Noncompliance Recall: Front Control Box OTA Software Update

Supersedes 20-051, dated July 29, 2020, to revise the information highlighted in **yellow**.

REVISION SUMMARY

Under REPAIR PROCEDURE – USB FLASH DRIVE, a note and image were added under step 13.

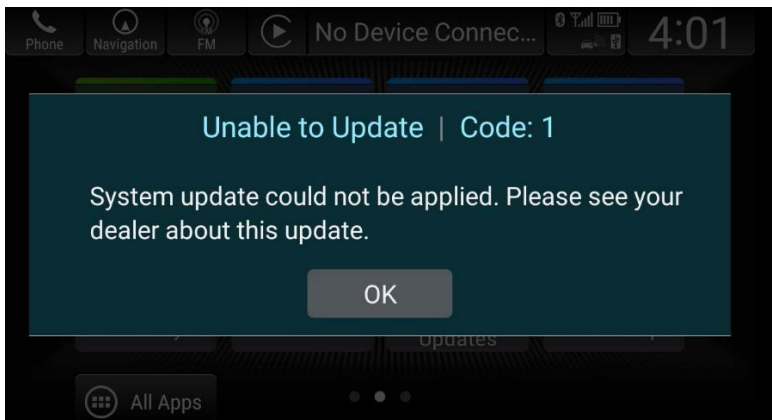
- If you encounter a message **Unable to Update | Code: 1** after seeing the image above, press OK and cycle the ignition.
